**IN THE MATTER** of applications by Meridian Energy Limited to Manawatū-Whanganui Regional Council, Greater Wellington Regional Council, Tararua District Council and Masterton District Council for resource consents to enable the construction, operation, and maintenance of a new wind farm on Mount Munro, located approximately 5km south of Eketāhuna

**SECTION 87F REPORT OF JOSHUA JAMES HUNT – LANDSCAPE**

**MANAWATŪ-WHANGANUI REGIONAL COUNCIL, GREATER WELLINGTON  
REGIONAL COUNCIL, TARARUA DISTRICT COUNCIL AND MASTERTON DISTRICT  
COUNCIL**

**15 March 2024**

**Figure 1:** Turbine Envelope Zone enforces separation

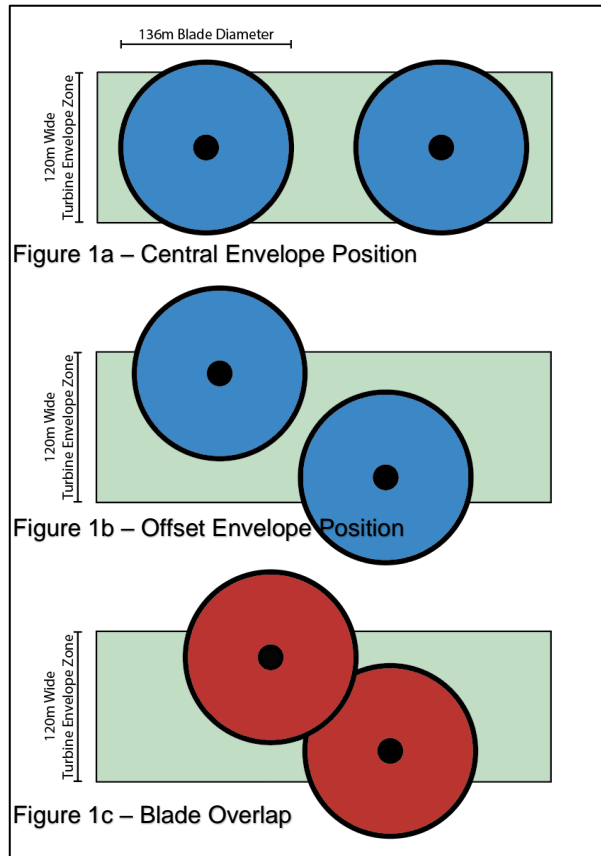
30 It is my understanding that the width of the proposed Turbine Envelope Zone (120m wide) is intentionally narrower than the turbine blade diameter (136m wide) as, when considered in plan view (Figure 1a, 1b & 1c), the combination of a rotating turbine hub (to always follow the wind direction) and the 120m wide Turbine Envelope requires the turbine layout to be spaced out along the identified ridges (e.g. so that the turbine blades cannot hit an adjacent turbine). This has the benefit of limiting dense clustering and 'double stacking' so that the wind farm has a *"visually balanced layout which responds well to the topography"*.<sup>24</sup>

**Figure 3:** Dwelling Visual Effects (Red = High, Yellow = Moderate-High, Green = Moderate or Mod-Low)

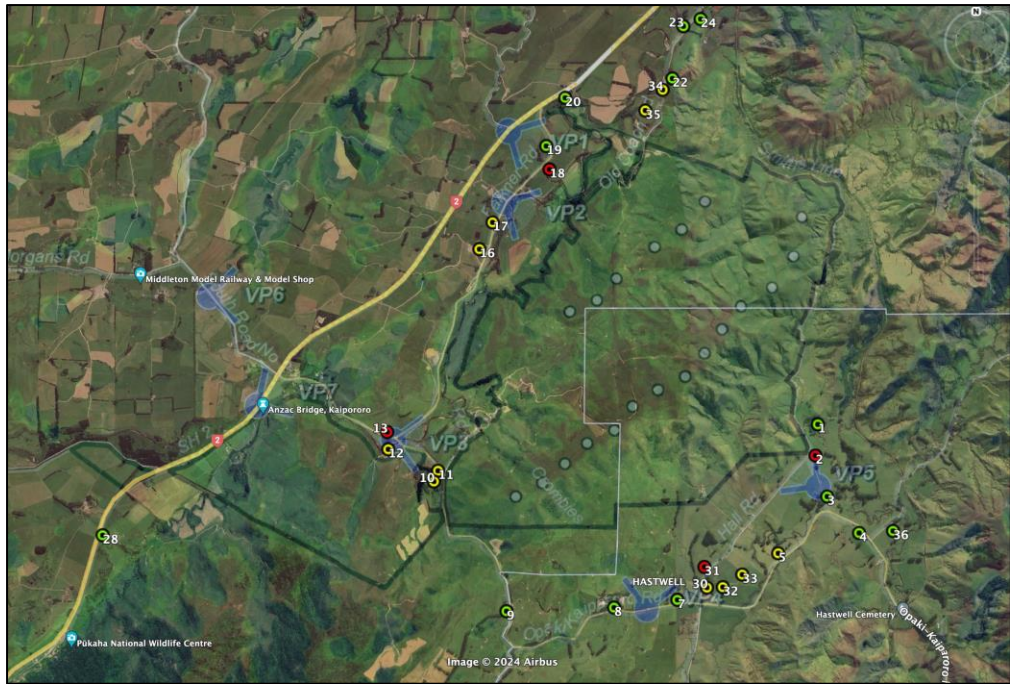
37 To clarify the visual effect rating on surrounding properties, Figure 3 below identifies those properties within 2km of a proposed turbine which have a High (indicated in Red), Moderate-High (indicated in Yellow), or Moderate/Moderate-Low (indicated in Green) visual effects rating. The dwelling numbers below are based on those identified in the LEA Appendix 3 and have excluded properties within the Project site.

Figure 1: Longer Distance Viewing Areas (Ref: Boffa Miskell LEV – Graphic Supplement, Figure 7)

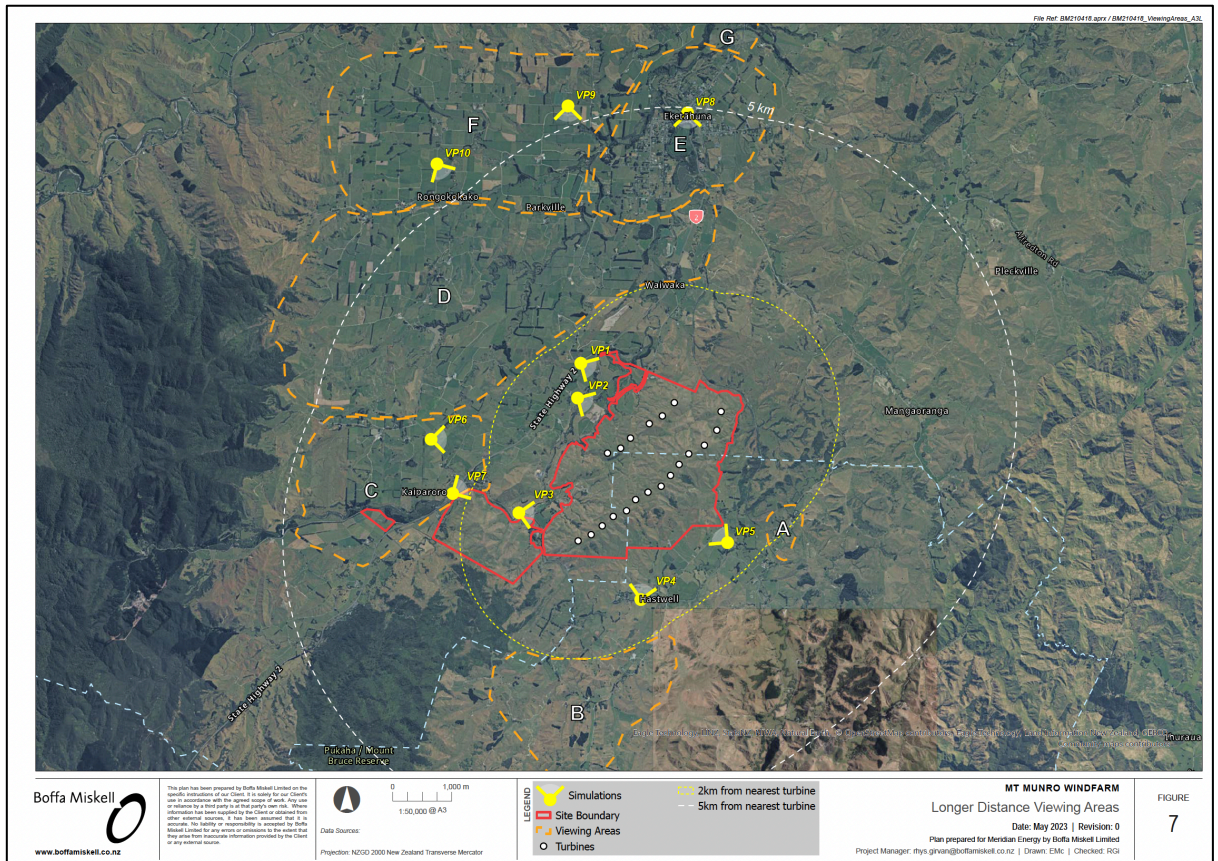
19. In order to determine which properties/dwellings within the 2km to 5km range need to be notified, further consideration of the level of visual effect associated with the grouped 'Viewing Areas' identified within Figure 7 of the LVA Graphic Supplement has been undertaken. The potential effects associated with the viewing areas (Figure 1) are identified in the following table, with commentary on these areas included within the LEA<sup>3</sup>.

20. The notification map (Attachment 1) has been produced based on identifying all properties within a 2km buffer distance from the proposed turbines, as well as including properties in the identified Longer Distance Viewing Areas between 2km and 5km.
